**13.2.2 DRAFT STRUCTURE PLAN - 303 (LOT 1) CORFIELD STREET, GOSNELLS**

Director: C Terelinck  
Author's Declaration Nil.  
of Interest:  
Property Number: 203957  
Application No: PF16/00006  
Applicant: Planning Solutions (Aust) Pty Ltd  
Owner: Zeditave Pty Ltd and Powerstar Pty Ltd  
Location: 303 (Lot 1) Corfield Street, Gosnells  
Zoning: MRS: Urban  
TPS No. 6: Development  
Review Rights: Yes. State Administrative Tribunal against any discretionary decision of Council.  
Area: 3.4663ha  
Previous Ref: Nil.  
Appendices: 13.2.2A Proposed Structure Plan Map  
13.2.2B Schedule of Submissions

A copy of the proposed SP is contained as Appendix 13.2.2A.

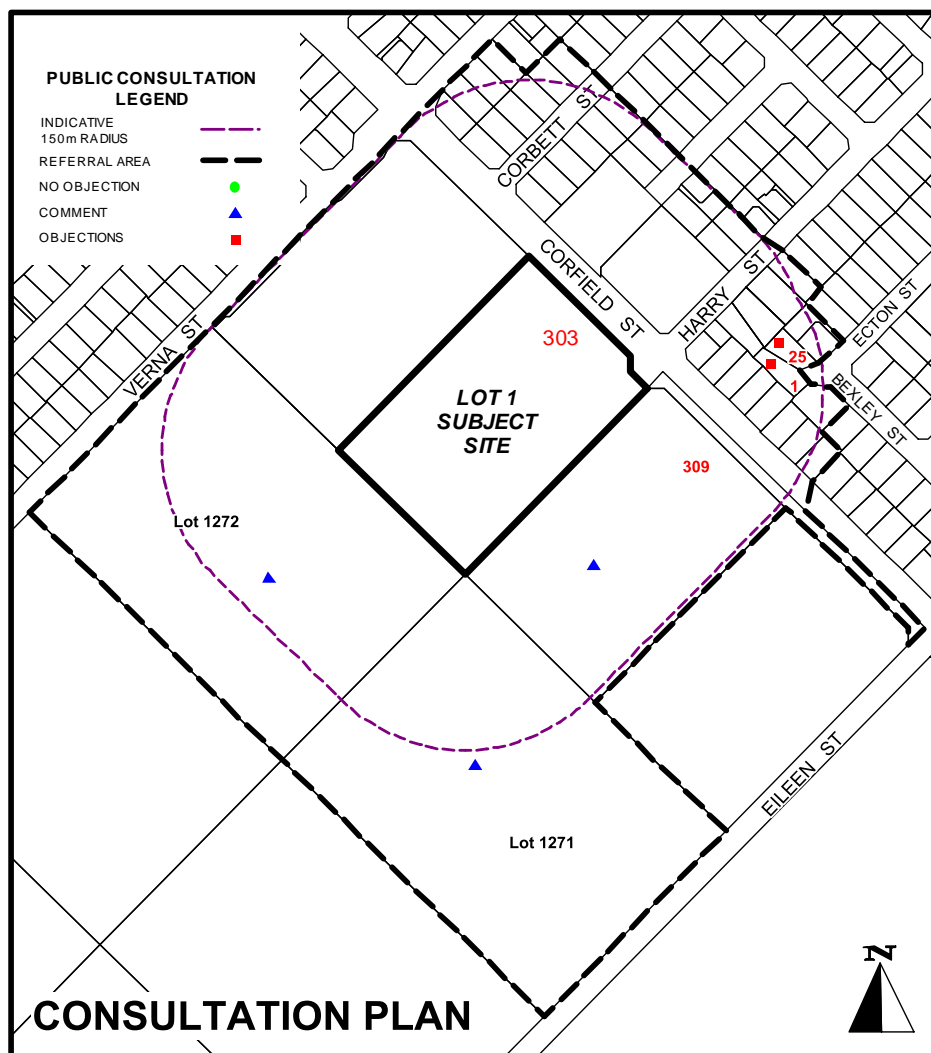
Based on the above, should Council consider recommending the SP be approved, it will be recommended that a modification be made to the SP map and text to replacing the Local Centre zoning with an Office zoning so that the adjacent sites are not directly competitive (Modification 1).

It will therefore be recommended that Council recommends to the WAPC that the SP not be determined until such a time as the landscape concept plan is modified to ensure grassed areas are not included directly adjacent to the wetland areas, as recommended by DPAW, to the satisfaction of the City and DPAW (Modification 2).

It will be recommended that the WAPC not approve the draft SP until the LWMS is formally endorsed by the City and the DoW, on advice of the Department of Parks and Wildlife (Modification 3).

The current BMP appears to be based on the proposed landscape plan that depicts grassed areas adjacent to the wetland and therefore low fuel loads within the REW buffer. As such, the BMP requires updating to reflect the DPAW's required amendments to the landscape plan and as a result of the updated BMP, the SP will require subsequent updating. Given the uncertainty as to the ultimate spatial outcome, it will be recommended the SP not be determined until such a time as the BMP (Modification 4) and subsequently, the SP (Modification 5) are updated to the satisfaction of the City and DPaW.

In addition, given the emergency access through the Local Centre site will not change in the future (as BAL levels do when surrounding land is developed), it is considered that a notation should be provided on the SP to ensure the retention of emergency access. As such, it will be recommended that prior to the SP being approved by the WAPC, the SP map should be updated to include a notation referencing the requirement for the emergency access to Corfield Street, as provided for in the BMP (Modification 6).

- The proposed roundabout treatment at the Harry Street and Corfield Street intersection has been discussed in the SP explanatory text, however is not shown on the SP map or within the implementation section of the SP text. It will therefore be recommended that prior to the SP being approved by the WAPC, the roundabout is to be shown on the SP map (Modification 7).

- Given the vehicle access movement through the Local Centre site is not proposed to be provided as a public road, the details of this connection should be assessed and determined once land uses and development outcomes are known, during the subdivision and development process, provided the emergency access is provided in accordance with the BMP requirements. As such, it will therefore be recommended that prior the SP being approved by the WAPC, the SP map shall be updated to include a notation indicating that vehicle access and egress at the Local Centre site will be limited to emergency access as provided in the BMP, and any proposed vehicle access to or from Corfield Street will be assessed as part of the relevant subdivision or development application (Modification 8).

No.	Recommended Modification and/or Information Requirement	Reason(s)
1.	The Structure Plan map and text being modified so as to replace the Local Centre zoning with an Office zoning.	The Local Centre zone is not an appropriate zone for the subject site.

2.	The landscape concept plan being updated to remove grassed areas adjacent to the wetland.	In accordance with DPAW's recommendation
3.	Endorsement of the Local Water Management Strategy by the City and the Department of Water and subject to any advice from the Department of Parks and Wildlife.	To provide a broad drainage strategy for the Structure Plan area so as to inform any future detailed drainage strategies forming part of subdivision proposals.

4.	The BMP being updated to reflect the amendments to the landscape plan.	To ensure the BMP is in accordance with the updated landscape plan.
5.	Any subsequent changes being made to the structure plan map as a result of the updated BMP.	To ensure that the Structure Plan map reflects the requirements of the BMP.

6.	The Structure Plan map being updated to include a notation referencing the requirement for the emergency access to Corfield Street, as provided for in the Bushfire Management Plan.	To ensure that the requirements of the Bushfire Management Plan are carried through to the structure plan requirements at the time of subdivision and development.

7.	The roundabout is to be shown on the Structure Plan map.	To ensure that the requirement for the roundabout to be provided at the time of subdivision is shown on the structure plan map.

8.	The Structure Plan map being updated to include a notation indicating that vehicle access and egress at the Local Centre site is limited to emergency access, as provided in the Bushfire Management Plan, and any proposed vehicle access to or from Corfield Street is to be assessed as part of the relevant subdivision or development application.	To ensure that the vehicle access to and from the proposed Local Centre site is considered in the context of the future development of the site and that the emergency access to and from that site is maintained.
